ADDENDUM NUMBER: One (1)

DATE: November 12, 2025

PROJECT: MONTGOMERY COUNTY EMS STATION 28

DESIGNER: DOUGLAS A. JONES, ARCHITECT
MONTGOMERY COUNTY ENGINEERING

C8.3

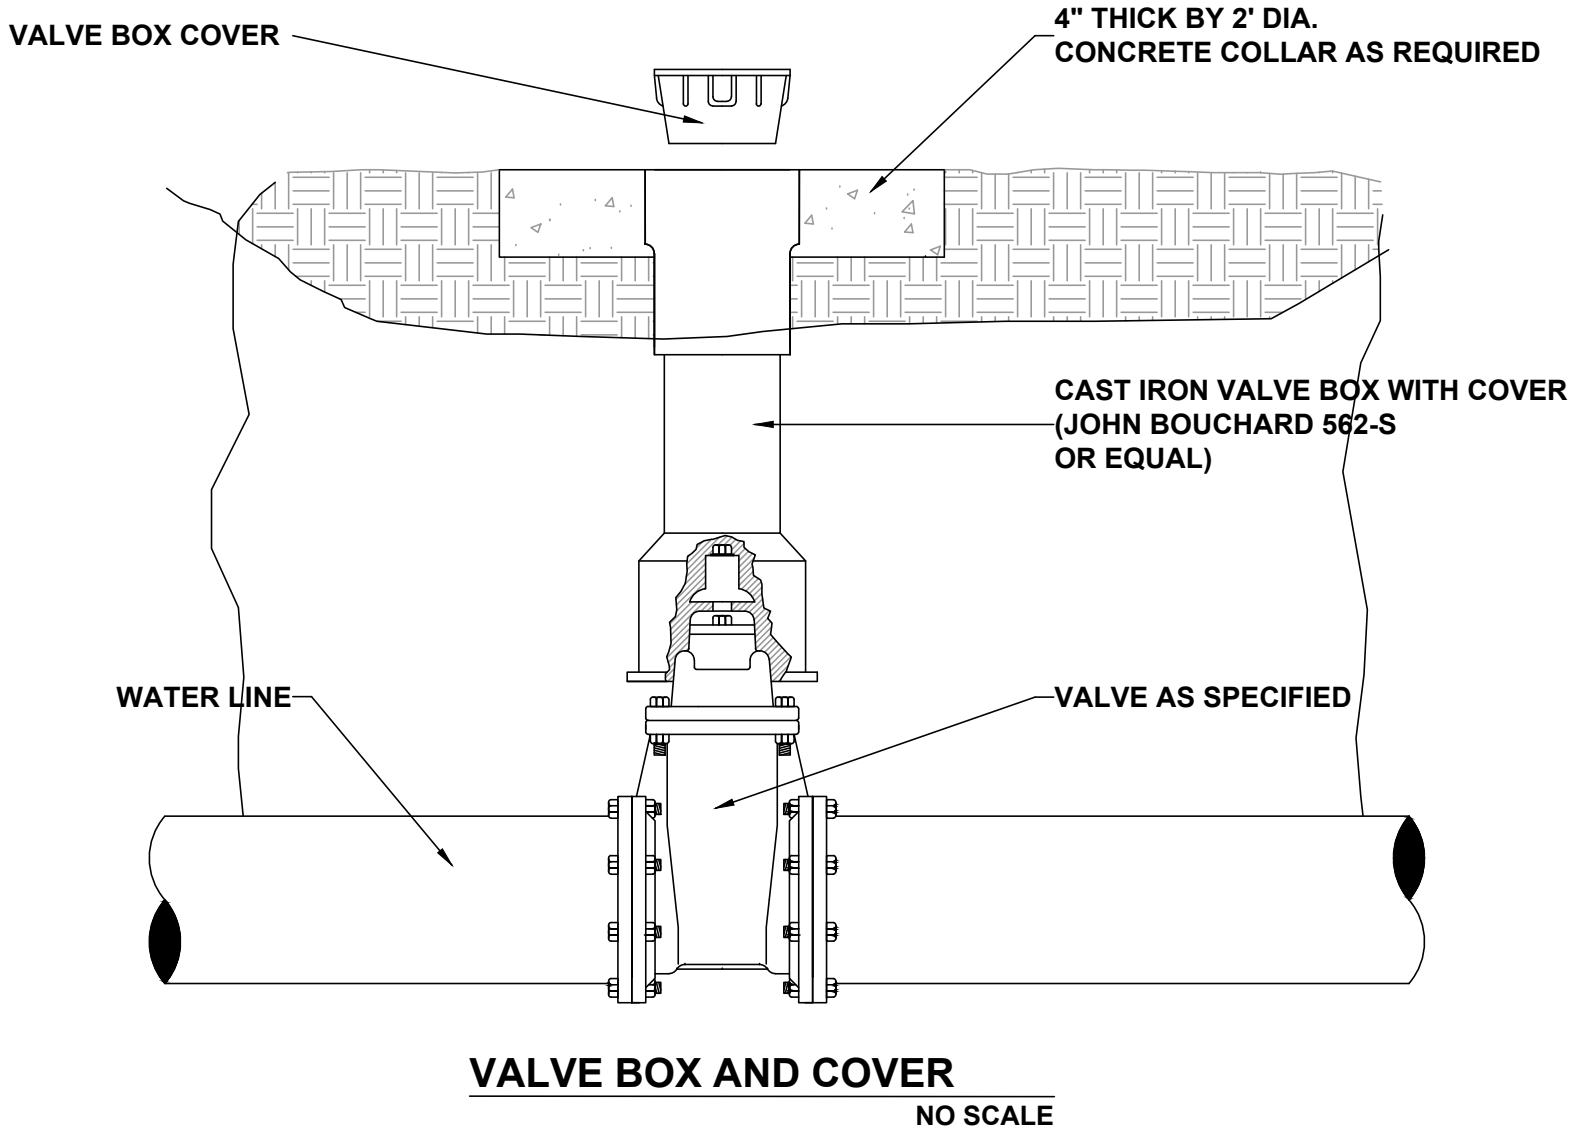
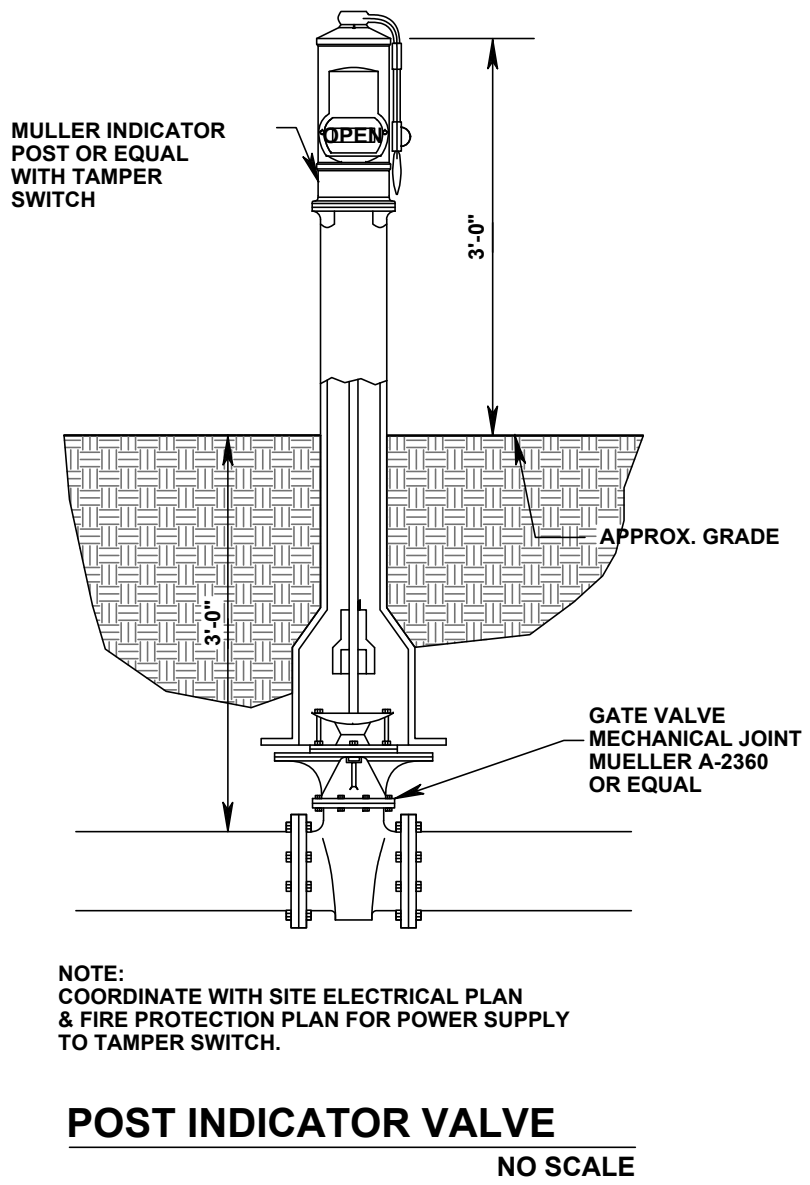
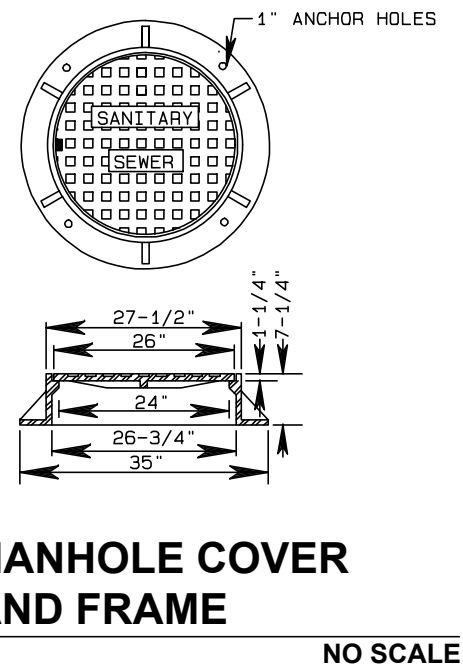
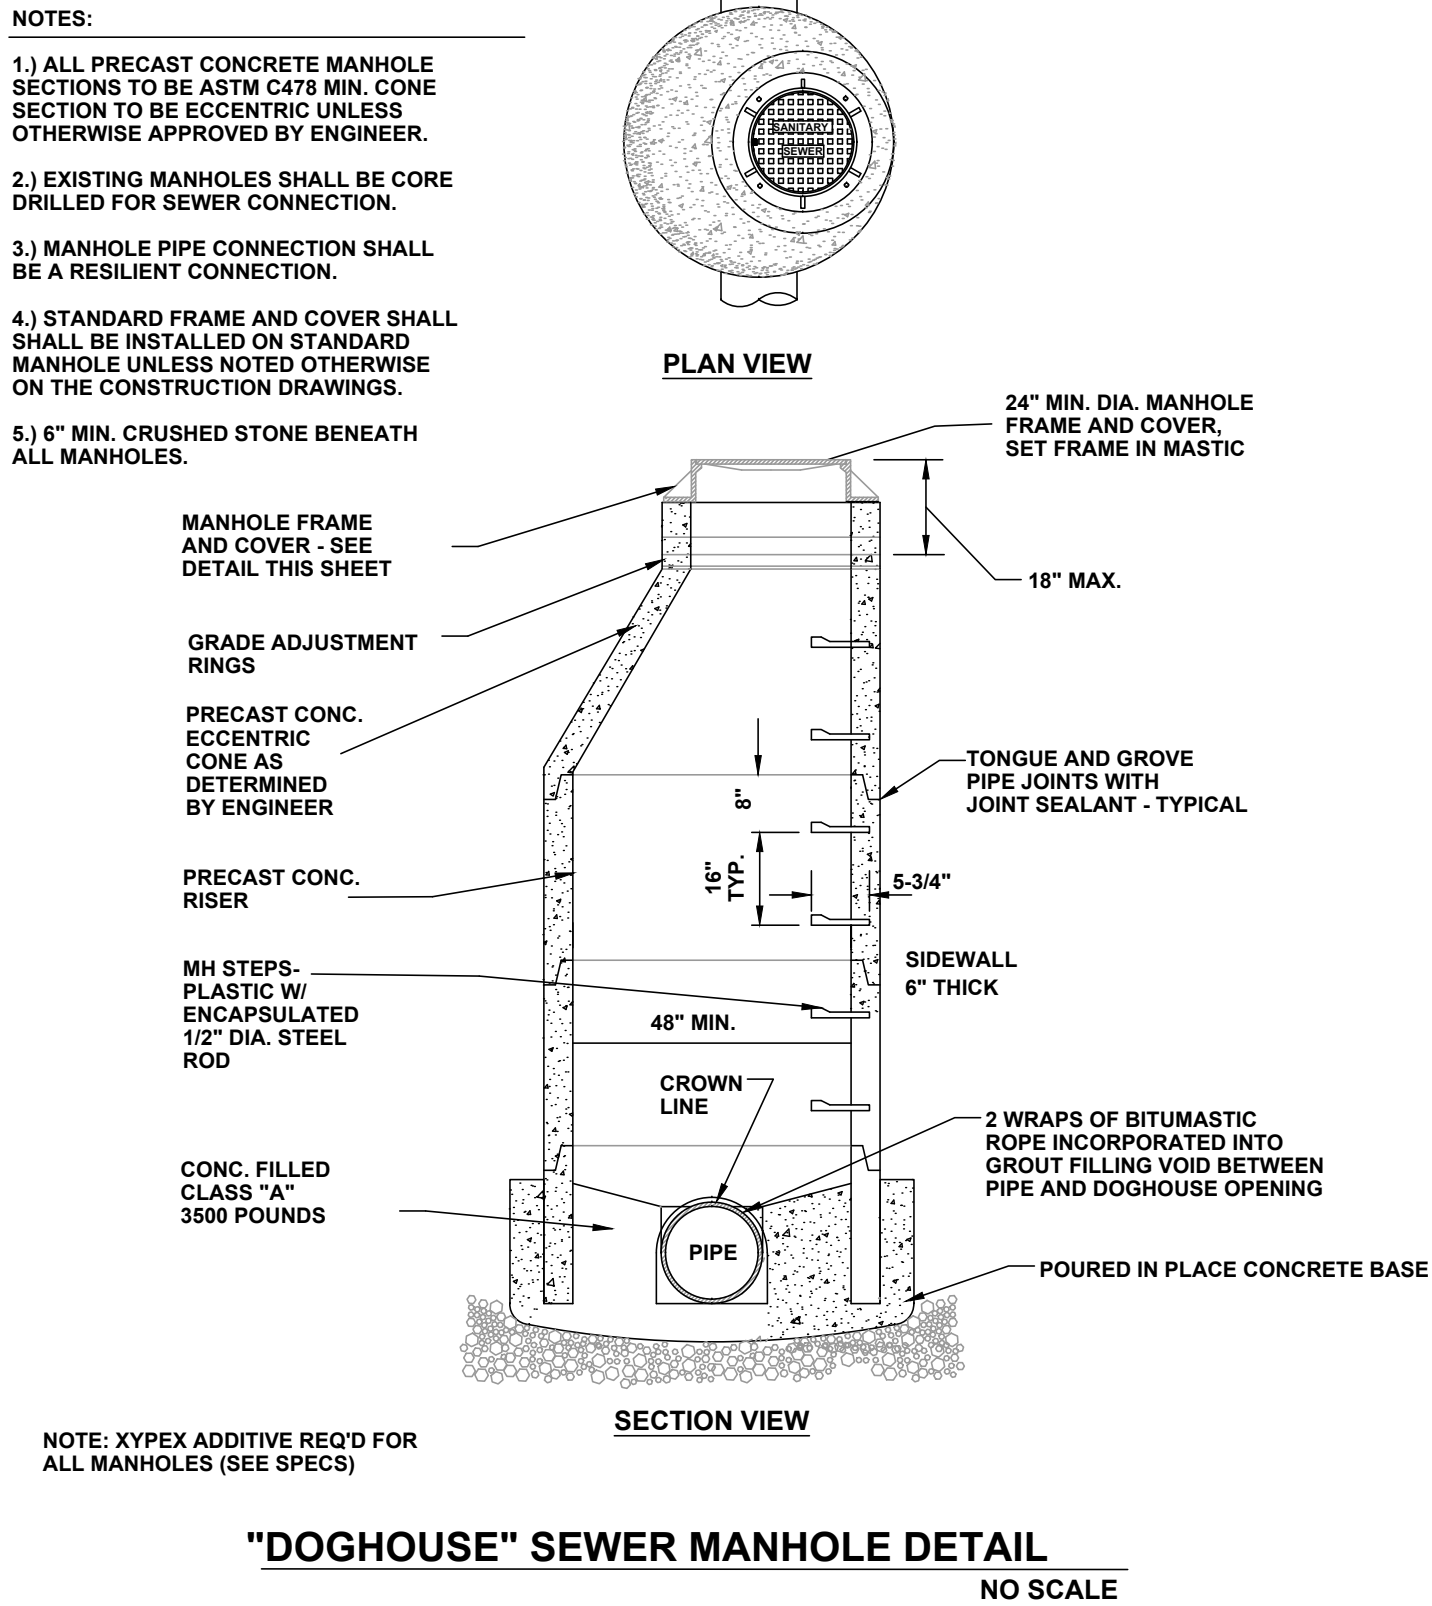
SHEET C8.3 - GENERAL SITE DETAILS; Delete Sheet C8.3 dated 11/03/2025 in its entirety. Substitute therefor: Sheet C8.3 - GENERAL SITE DETAILS dated 11/12/2025 attached hereto.

Clarification: Deleted Sanitary Manhole Detail and moved Rip Rap Detail to sheet C8.6.
